Legalelectric, Inc.

February 21, 2024

RE: No CapX 2020 EIS Scoping Comment & Exhibits
MN Energy CON - Lyon Co. to Sherco Transmission Line
PUC Dockets E001/CN-22-131 and E001/TL-22-132

Figure 3-2: NSP System Median Base Summer Peak Demand (MW)
(Includes modeled EE Adjustment)

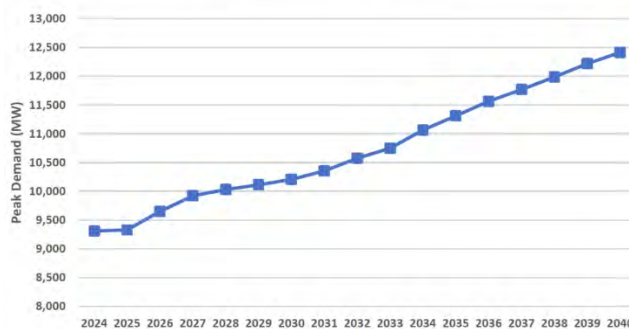
The EIS must also address timing of Xcel’s convenient claim of an annual 1.8% increase in peak demand, as of its just filed Integrated Resource Plan, PUC Docket RP-24-67. It contains a chart that is eerily reminiscent of the grossly overblown CapX 2020 demand projections, see IRP Chapter 3, page 2 of 29:

That IRP projection is laughable. Referring to their CapX peak demand projections as “grossly overblown” is not hyperbole. Here is their peak demand as taken from the Xcel Energy 10-K filings with the SEC:
